TE Connectivity

Product Change Notification: PCN-21-124189

Revise 114-18458-1 Figure 6 : Delete "wire not contact housing" Figure 8 : Add an unacceptable cable condition

Figure 6

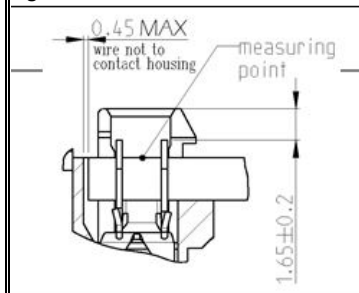
Figure 6 : with %22wire not contact housing%22

Figure 6

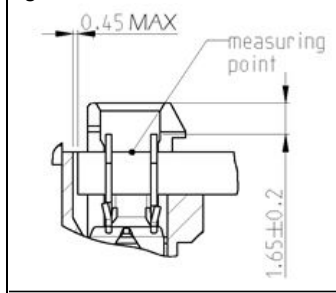
Figure 6 : Delete %22wire not contact housing%22

Figure 8

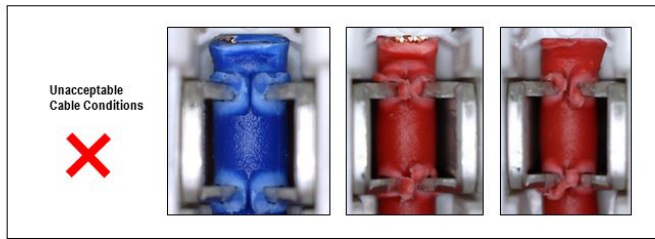
Figure 8 : have 3 unacceptable cable conditions

Figure 8

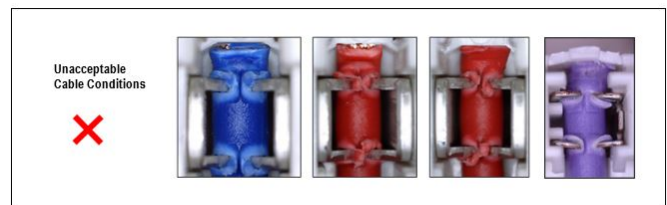
Figure 8 : Add an unacceptable cable condition
